1995–2004—The following GM service bulletins confirm a pattern of engine intake manifold gasket defects, which are sometimes covered by a 6-year/100,000 km secret warranty. Here they are presented from the earliest to the latest per Alldata garage bulletin subscription I subscribe to:

Bulletin No.: 01-06-01-007A

Engine Coolant Consumption or Coolant Leak
(Inspect For Material Degradation/Replace [Intake Manifolds](#))

Engine Oil or Coolant Leak (Install New Intake Manifold Gasket) # 03-06-01-010B - (10/24/2003)

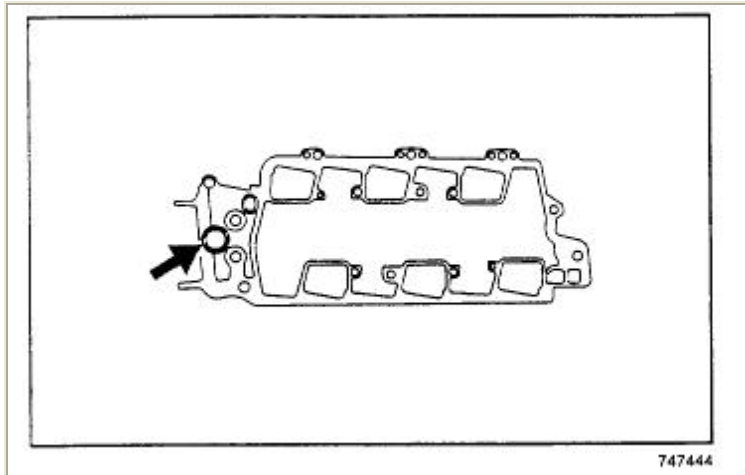
Some owners may comment on excessive engine coolant consumption, or an engine coolant leak near or under the throttle body area of the upper intake manifold.

Upper intake manifold composite material may degrade around the EGR stove pipe and could result in an internal or external coolant leak.

2. Refer to the arrow in the illustration of the upper intake manifold above. Inspect the inner diameter of the EGR passage for signs of material degradation. Degradation will appear as "pitting" of the composite material in the EGR port passage.

3. If degradation of upper intake manifold composite material is found, replace the lower and upper intake manifolds with the following part numbers:
 - ^ Lower Intake - 24508923

- ^ Upper Intake - 17113136 (includes necessary upper intake plenum gaskets)
 - ^ Lower Intake Gasket - 12537197
4. Follow the lower and upper intake manifold installation instructions found in the Engine Unit Repair Section of the appropriate Service Manual.

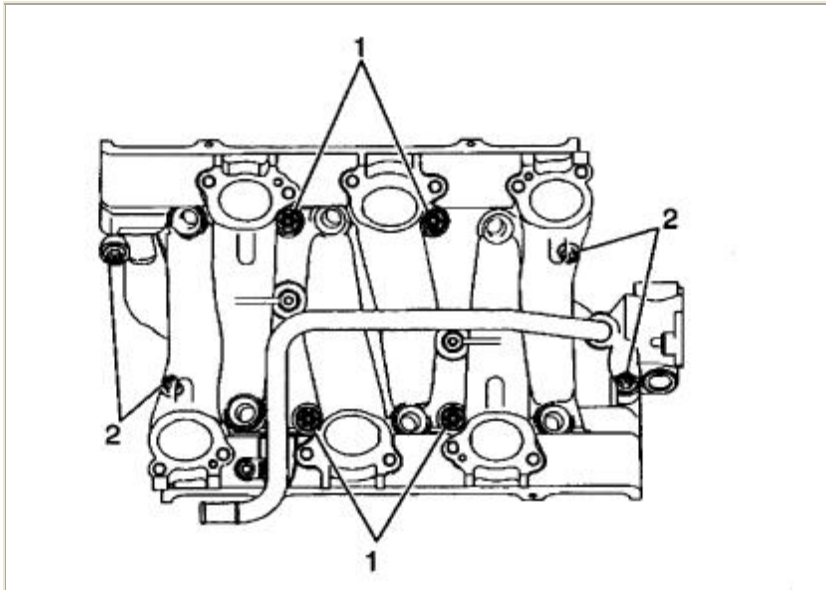
Some owners may comment on an apparent oil or coolant leak. Additionally, the comments may range from spots on the driveway to having to add fluids.

[Intake manifold](#) may be leaking allowing coolant, oil or both to leak from the engine.

Install a new design [intake manifold gasket](#). The material used in the gasket has been changed in order to improve the sealing qualities of the gasket. When replacing the gasket, the [intake manifold](#) bolts must also be replaced and torqued to a revised specification. The new bolts will come with a pre-applied threadlocker on them.

Notice An oil leak may result if the vertical bolts are not tightened before the diagonal bolts.

1. Tighten the vertical lower intake manifold bolts (1) to 7 N.m (62 lb in).
2. Tighten the diagonal lower intake manifold bolts (2) to 7 N.m (62 lb in).
3. Tighten the vertical lower intake manifold bolts (1) to 13 N.m (115 lb in).
4. Tighten the diagonal lower intake manifold bolts (2) to 25 N.m (18 lb ft).
